**Subject:** MHI's Response to US-APWR DCD RAI No. 498-3782

Response to Request for Additional Information No. 498-3782,  
Revision 0 (60-day response)

**US-APWR Design Certification  
Mitsubishi Heavy Industries  
Docket No. 52-021**

**RAI NO.: NO. 498-3782 REVISION 0**  
**SRP SECTION: 03.09.02 - Dynamic Testing and Analysis of Systems Structures and Components**  
**APPLICATION SECTION: 3.9.2**  
**DATE OF RAI ISSUE: 12/01/2009**

Figure 1 Reactor General Assembly

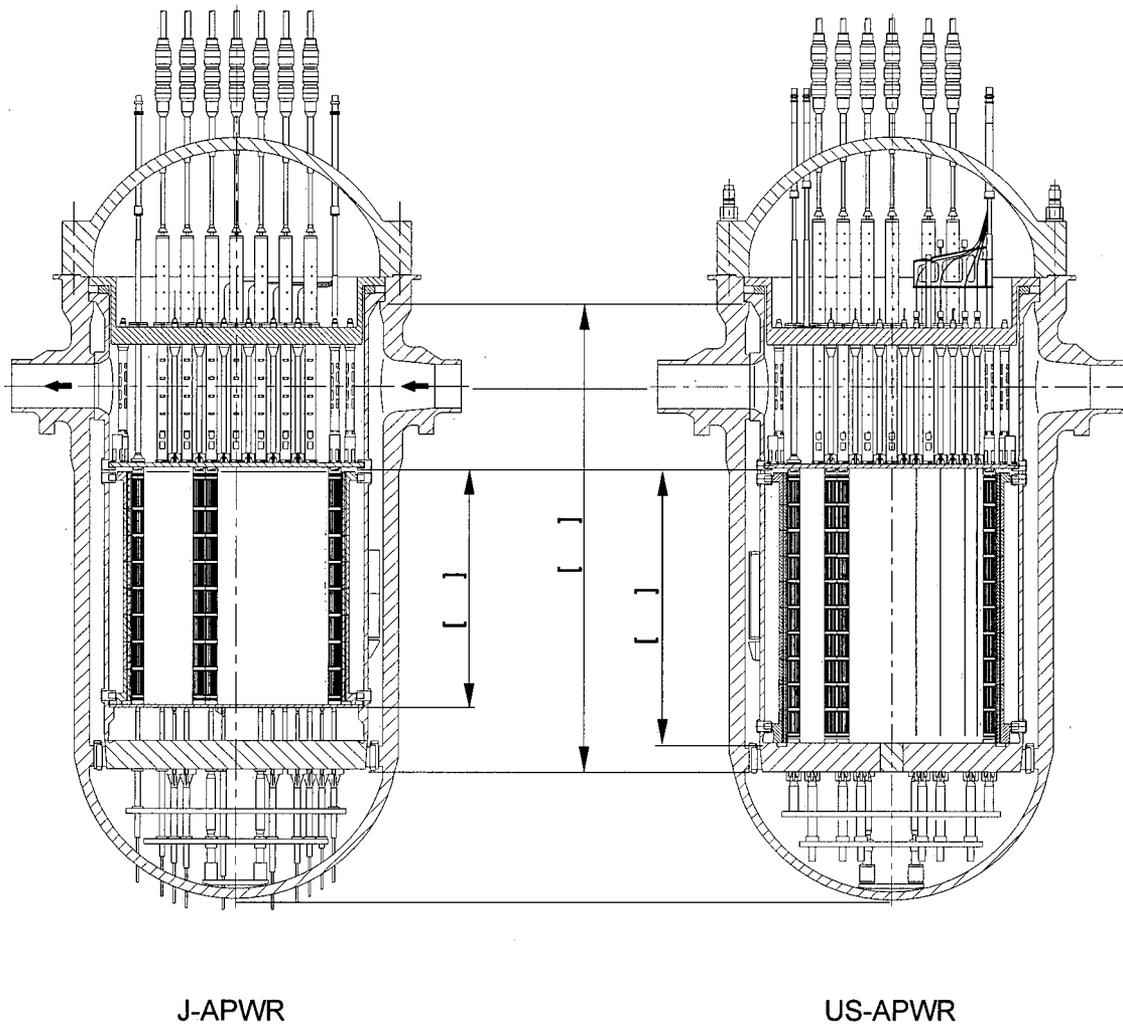
In the response to RAI 3.9.2-21 (#272-1585, dated 4/9/2009, ML091040693, MHI Ref: UAP-HF-09149), the applicant addressed the global differences between the US-APWR and the 1/5 SMT. In doing so, they did not clarify other differences which may appear small but can have important effect on the test results. For example, Fig. 3-2 in Report MUAP-07023-P indicates that the scale model has a lower core plate and a lower support plate, whereas Fig. 2.1-1 in Report MUAP-07027-P shows that the US-APWR has one plate only (lower core support plate). Such discrepancies between documents are not acceptable. The applicant is therefore requested to explain the reasons for these differences (and others which may not be apparent in the above noted figures), and to clarify the effect of these differences on the test results, structural modeling and forcing functions. The applicant is also requested to update SMT Report MUAP-07023-P so that it reflects the true geometry of the tested model and to include in the report any differences from the US-APWR and the effects of these differences on the test results.

The US-APWR is a 14 ft-core version derived from the J-APWR design, which has a 12 ft core. Specifications of the reactor internals of the J-APWR and the US-APWR are compared in Table 1. Comparisons of the schematic drawings are shown in Fig. 1 to 6.

Although the core length of the US-APWR is extended from that of the J-APWR, the dimensions of the reactor vessel and core barrel are not changed as shown in rows 1 and 2 in Table 1. This is obtained by eliminating the space between the lower support plate and the lower core plate and replaced these two plates with an integrated LCSP design. Therefore, the vibration characteristics of the core barrel can be simulated by integrating the LCP and the LSP as stated in row of 4 in Table 1.
